TECHNICAL SERVICE BULLETIN

Group:	42-REAR AXLE
Bulletin No:	SB-17-005
Issue Date:	1-24-2017
Reference:	HMM-161027-F1

UPDATED 21K / 23K REAR AXLE S-CAM BRACKET FOR SEVERE DUTY

SUBJECT VEHICLES: 08MY-17MY Conventional Trucks equipped with air brakes.

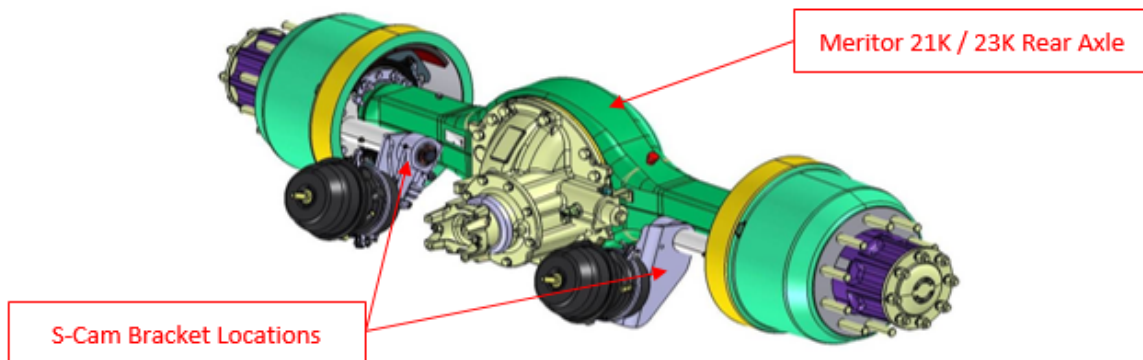
Vehicle's equipped with a unique body configuration, or that operate in a severe environment, may experience a 21k or 23K rear axle s-cam bracket crack or fracture. In the rare event this occurs, an enhanced s-cam bracket is available to extend the service life of this component.

PART NUMBER	DESCRIPTION	QUANTITY
V653299Q6257	21K Right Rear S-Cam Bracket	(1) As Required
V653299P6256	21K Left Rear S-Cam Bracket	(1) As Required
V663299Q6257	23K Right Rear S-Cam Bracket	(1) As Required
V663299P6256	23K Left Rear S-Cam Bracket	(1) As Required

When replacement of the s-cam bracket(s) is necessary, refer to the Hino workshop manual section “*BR02-002 Service Brake(Full Air Brake)*” for the appropriate disassembly, inspection and reassembly procedures.
